COLLINS SUBDIVISION, FIRST ADDITION,
RESUBDIVISION OF LOTS 10 - 12

APPLICATION NUMBER 1 DATE June 4, 2020
 APPLICANT Collins Subdivision, Resubdivision of Lots 10-12, First Addition
 REQUEST Subdivision

DETAIL SITE PLAN

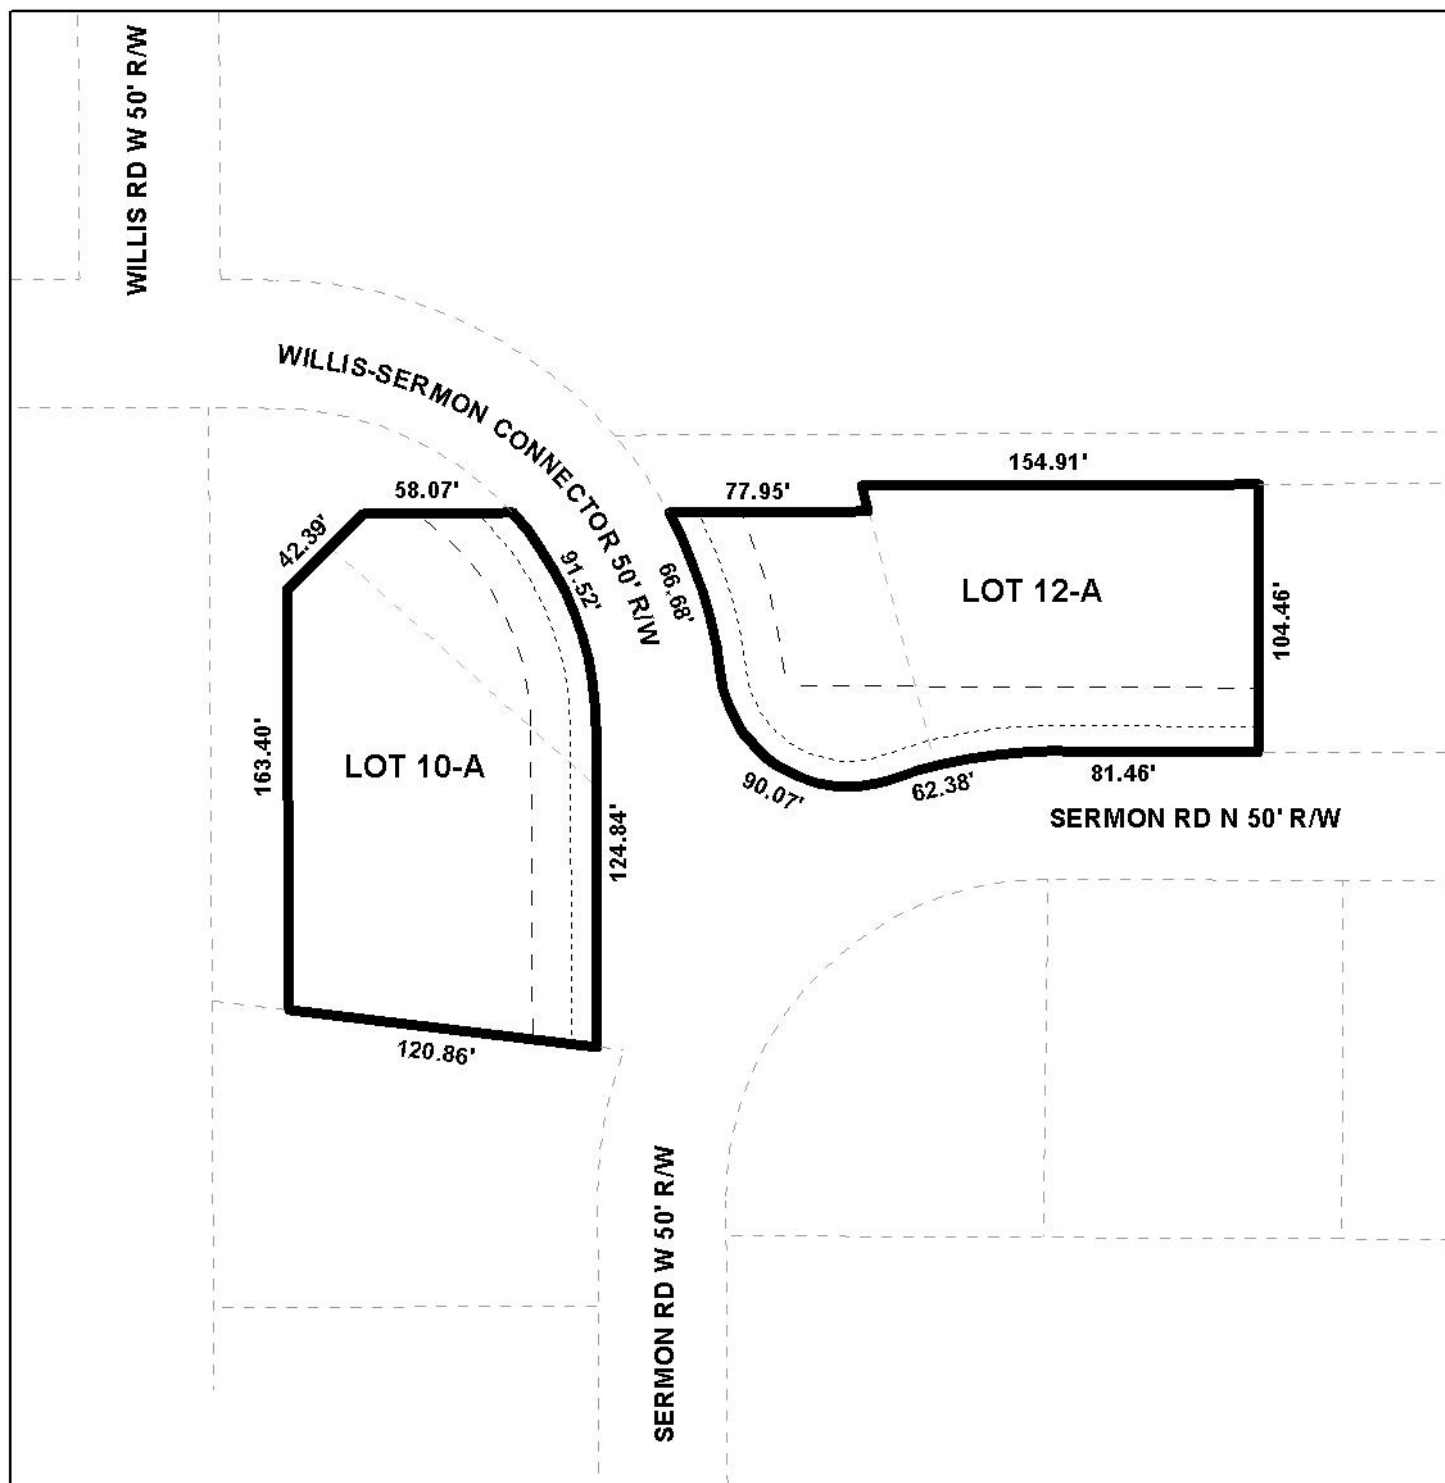
- B. Willis-Sermon Connector (50' ROW) has not been recorded. It is still considered a Private Road that was proposed under Land Disturbance Permit BLD2013-03279. The permit is still open.

- C. Show and label each and every existing and proposed Property Line, Public and Private Right-Of-Way, and easement.
- D. Provide the Surveyor's, Owner's (notarized), Planning Commission, and Traffic Engineering signatures.

- E. Additional drainage easements may be required for drainage system installed along the Private Road.
- F. Add a note to the SUBDIVISION PLAT stating that a Land Disturbance permit will be required for any land disturbing activity in accordance with Mobile City Code, Chapter 17, Storm Water Management and Flood Control; the City of Mobile, Alabama Flood Plain Management Plan (1984); and, the Rules For Erosion and Sedimentation Control and Storm Water Runoff Control.

It should be noted that a Right-of-Way development permit was issued in 2014 for Land Disturbance for the construction of the Willis-Sermon Connector. However, there were never any inspections during construction, and the City never accepted the connector, and the Land Disturbance permit for its construction is still open. As it stands now, the connector is still on private property and is considered a private street, although no Planned Unit Development Approval request was ever submitted for a private street. As the preliminary plat submitted for this subdivision review indicates the street as a public right-of-way, and as no record of acceptance as a public right-of-way has been presented, staff cannot entertain a review of the subdivision, as proposed. Therefore, this application is recommended for holdover to the meeting of March 19th to allow the applicant to provide documentation that the connector is indeed an accepted public-right-of-way as shown on the preliminary plat, or submit a PUD.

- 1) provide documentation that the Willis-Sermon Connector is an accepted and open public right-of-way as indicated on the preliminary plat; or
- 2) submit a Planned Unit Development Approval application to allow Willis-Sermon Connector as a private street to be heard in conjunction with a revised preliminary plat as a private street subdivision.

Based upon the preceding, this application is recommended for holdover to the meeting of March 19th, with revision to be submitted by February 17th, to allow the applicant to address the following items:
